## Robinson Terminal North – Proposed building on the west side of North Union

West building

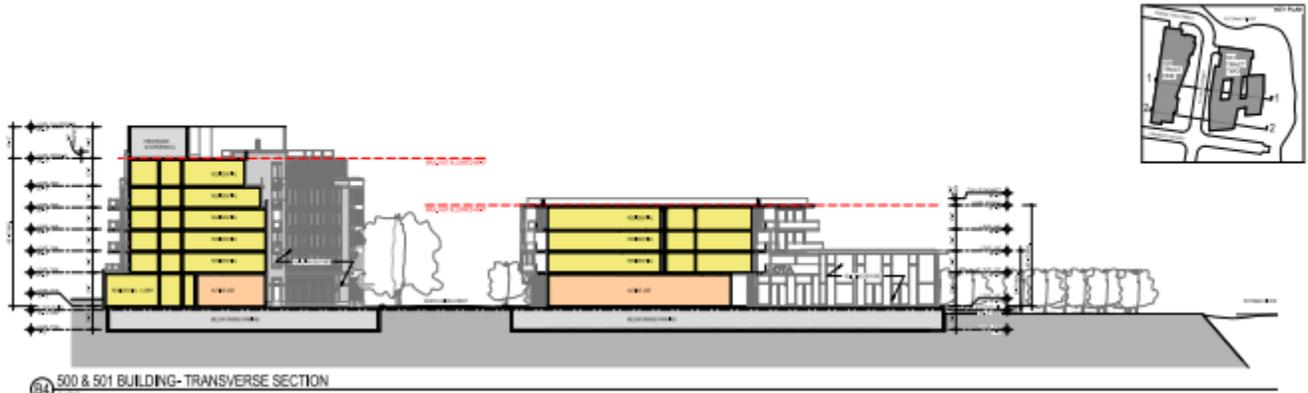
Two things stand out immediately when considering the size and design of West building (i.e. on the west side of North Union Street) of the proposed North Robinson Terminal development project. Those factors should preclude the building, and the entire project, from being approved by the BAR as the proposed building violates both the Potomac River Vicinity and Potomac River Height ordinances.

- First, the height ordinance limits the building height to 30 feet, which is clearly exceeded. See zoning ordinance below:

- Second, the proposed building deliberately distances itself from the architectural fabric of Old Town in an attempt to stand out or apart from it, claiming it will be Iconic. The Potomac River Vicinity ordinance, and the Old and Historic District ordinance itself for that matter, makes that illegal and should in itself preclude the proposal from going forward. See the ordinance below, specifically for the Potomac River Vicinity
